East Port Water Reclamation Facility Expansion

CCU Change Order Request
East Port WRF Expansion - CCU File # 18-0006
Change Order 1

Change Order # 1

Change Order Form

SEPTAGE RECEIVING STATIONS

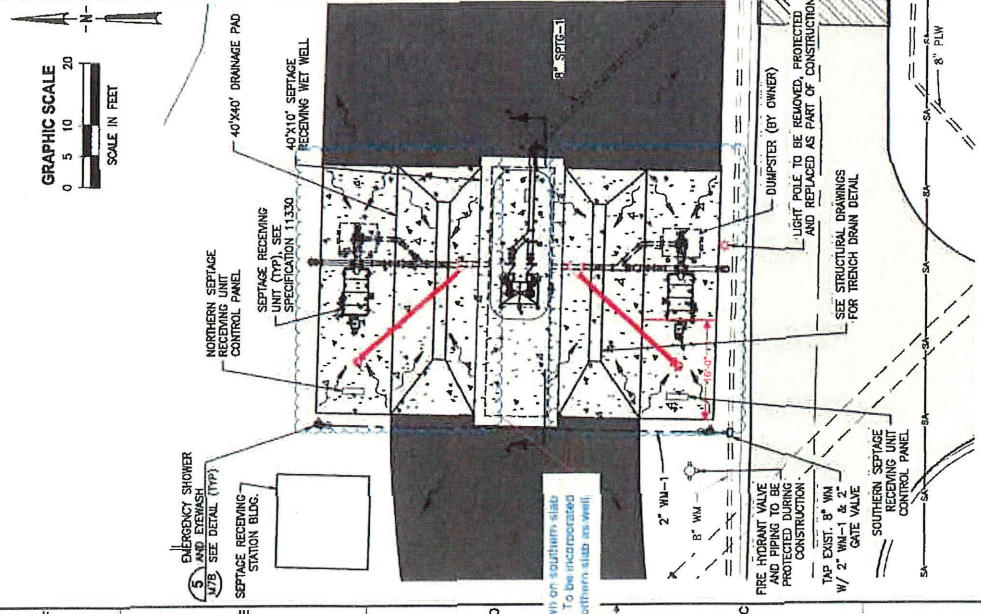
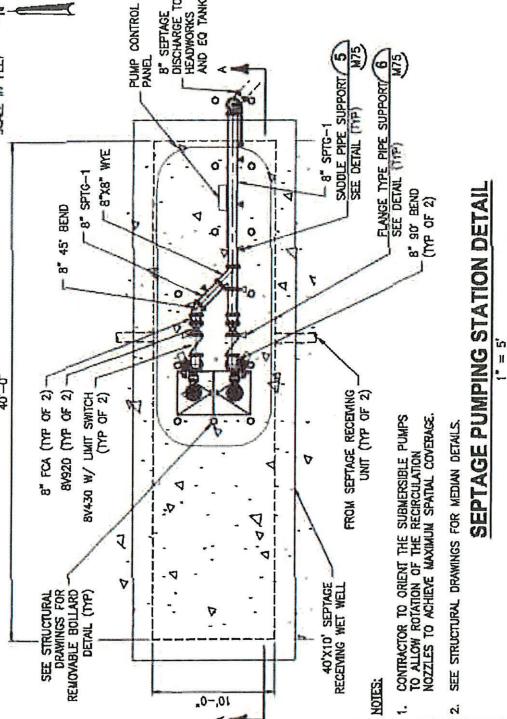
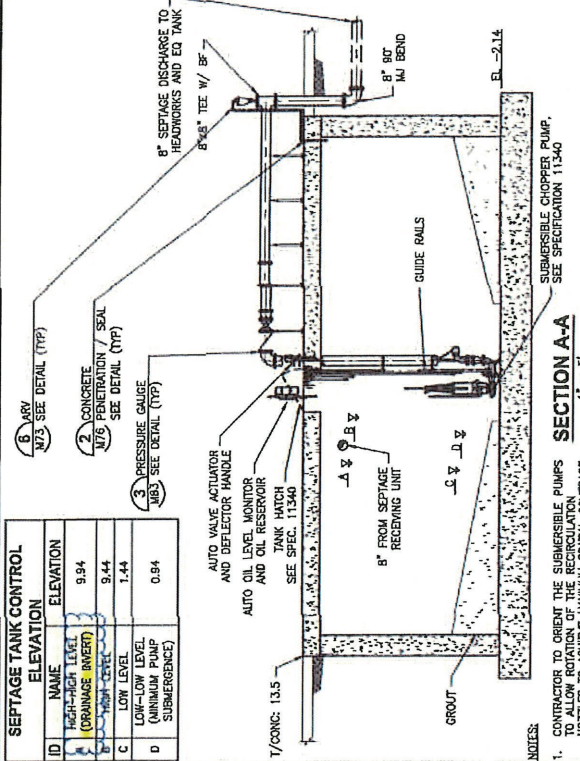
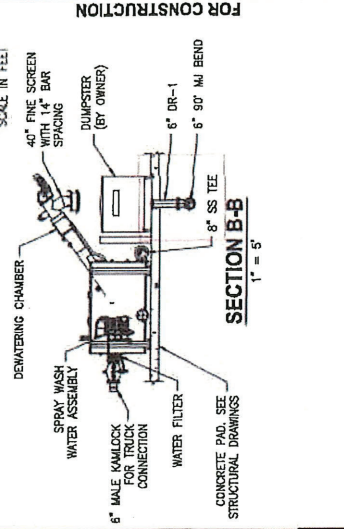
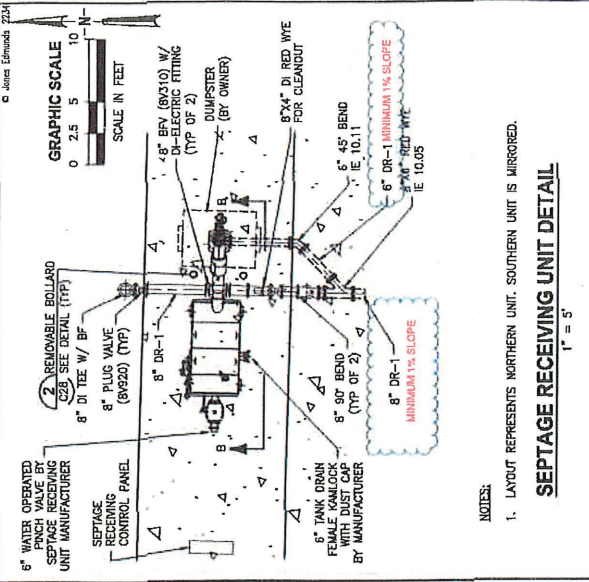
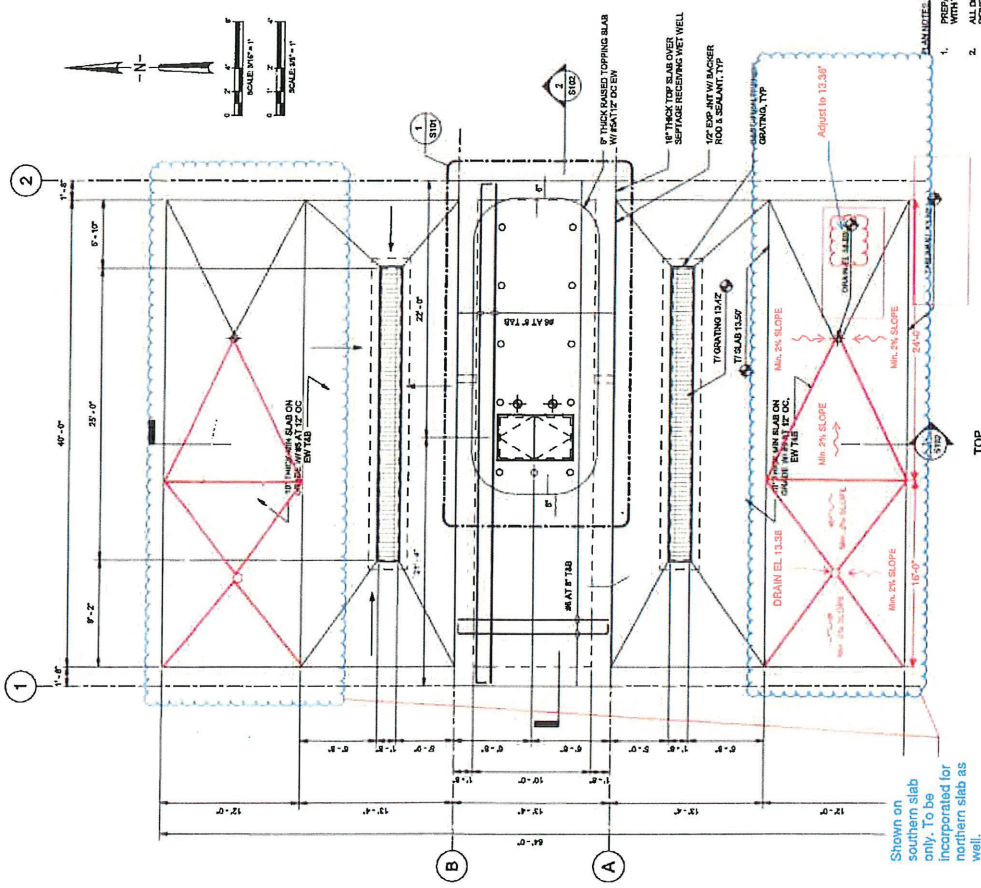
CONTRACT DOCUMENT REFERENCE(S): Markup M 72, S 101, and Submittal Excerpt

DESCRIPTION OF MODIFICATION: The Contractor is requested to provide an equitable itemized proposal to revise the 8" DIP Drain Piping and Slope configuration at the New Septage Receiving Station. Included in this modification will be (2) two additional 8" Drains and associated Underground piping and fittings. Per the attached markup drawings a minimum of 2% slope is required for all slab surfaces at the two septage receiving bays.

REASON FOR MODIFICATION: Preference to assure Drainage and Washdown Maintenance.

ENLARGED PLAN
3/4" = 1'-0"

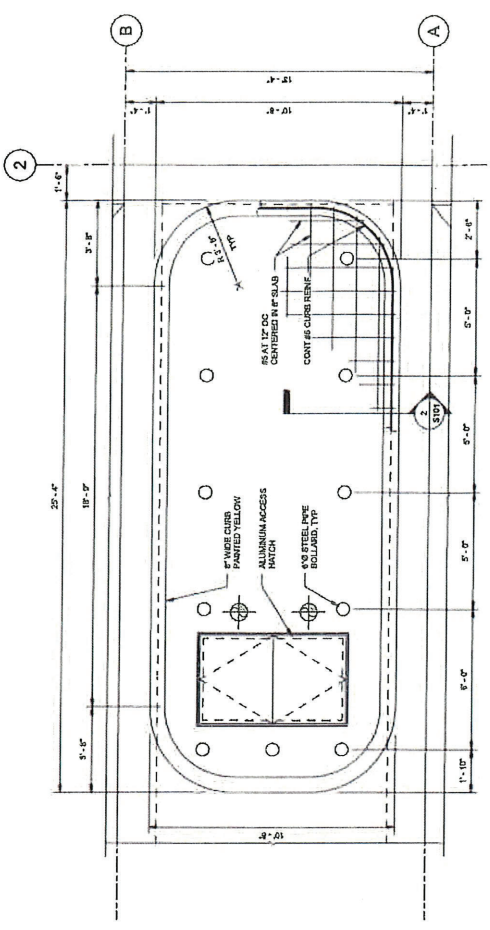
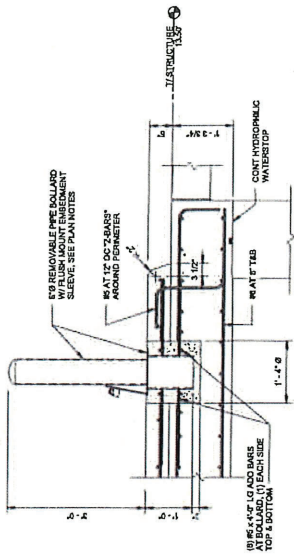
Shown on
southern slab
only. To be
incorporated for
northern slab as
well.

LAYOUT OF SEPTAGE RECEIVING STATION SLAB REINFORCING DETAILS

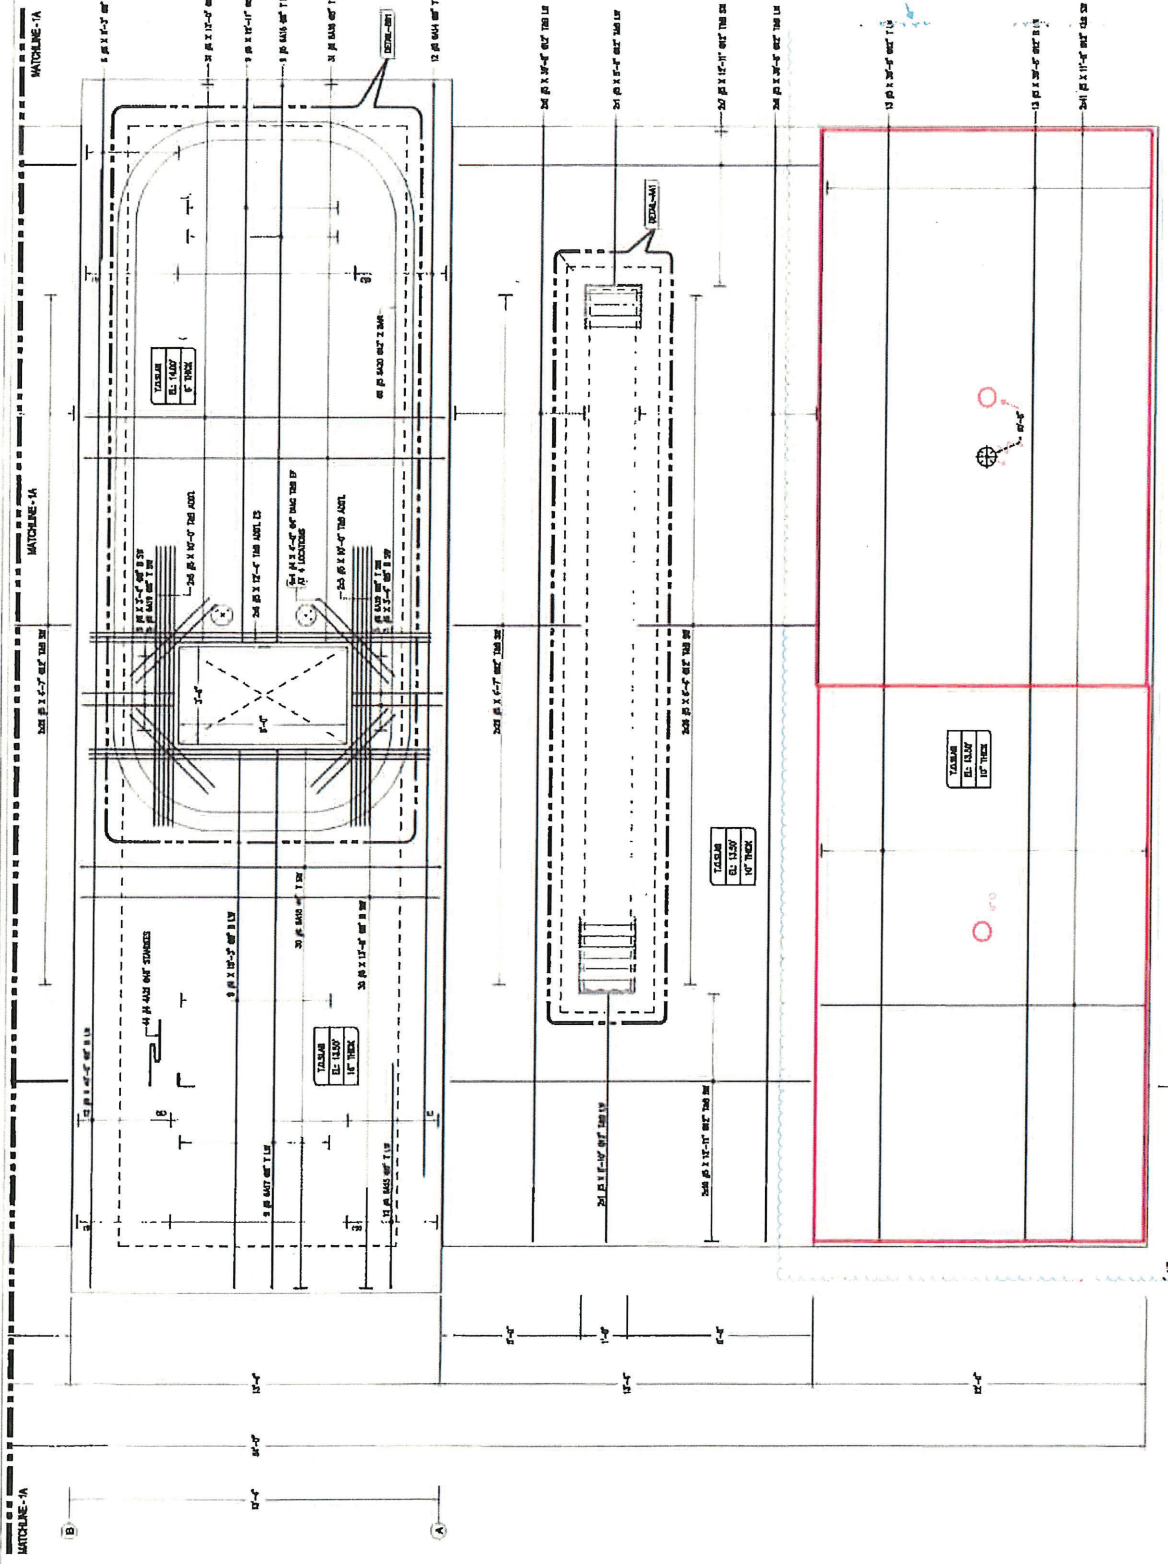
REVISED SLOPE AND DRAIN(S) CONFIG

REVISE & RESUBMIT

REVISE &
RESUBMIT

RESPONSE: OK

JE RESPONSE:
OKAY

PLAN VIEW

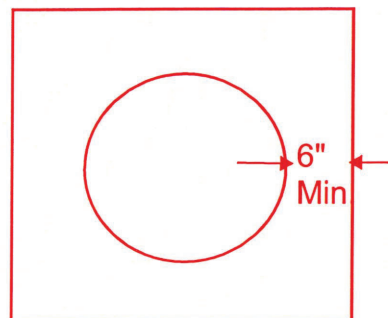
DESCRIPTION OF MODIFICATION: The Contractor is to provide an equitable itemized proposal for the work related to the Abandonment of the 18-Inch Diameter Vertical DIP Pipe within the New EQ Tank, as indicated in the attached sketch. The Drawings and Specifications do require that the Pipe be removed from the Tank Area.

However, the Contractor is entitled to additional reimbursement to complete the detailed additional concrete cap, as shown per the attached sketch.

Measure Depth to UG Bend. Fill all but 2 LF with rip rap rubble.

Install # 5 rebar mat 8" OC and fill to existing slab grade with 4000 psi concrete. Trowel smooth.

CUT 18" DIP 5" Below Existing Slab

Remove 5" of existing slab

Apply Sika Lockstop Waterstop continuous all sides.

Dowel in bars , 4" embed each end. Provide 3" of clear cover to top of rebar w/ 18" Lap. (typical).

PLAN VIEW

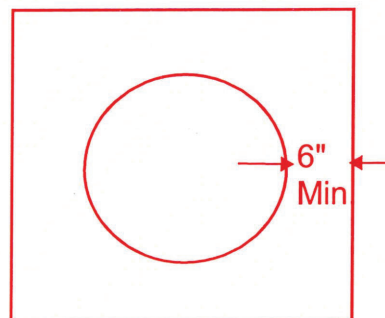
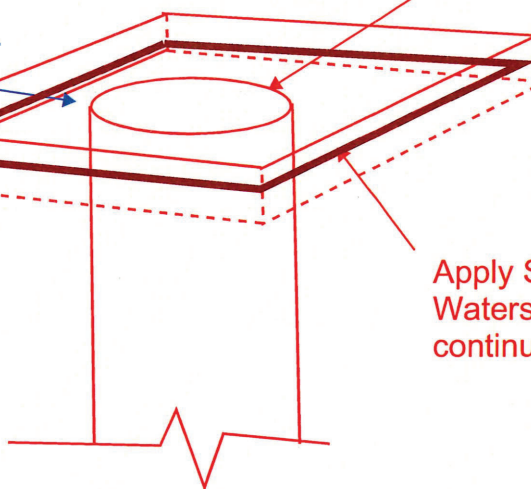
DESCRIPTION OF MODIFICATION: The Contractor is to provide an equitable itemized proposal for the work related to the Abandonment of the 18-Inch Diameter Vertical DIP Pipe within the New EQ Tank, as indicated in the attached sketch. The Drawings and Specifications do require that the Pipe be removed from the Tank Area.

However, the Contractor is entitled to additional reimbursement to complete the detailed additional concrete cap, as shown per the attached sketch.

Measure Depth to UG Bend. Fill all but 2 LF with rip rap rubble.

Install # 5 rebar mat 8" OC and fill to existing slab grade with 4000 psi concrete. Trowel smooth.

CUT 18" DIP 5"
Below Existing
Slab

Remove 5" of
existing slab

Apply Sika Lockstop
Waterstop
continuous all sides.

Dowel in bars , 4"
embed each end.
Provide 3" of clear
cover to top of rebar
w/ 18" Lap. (typical).
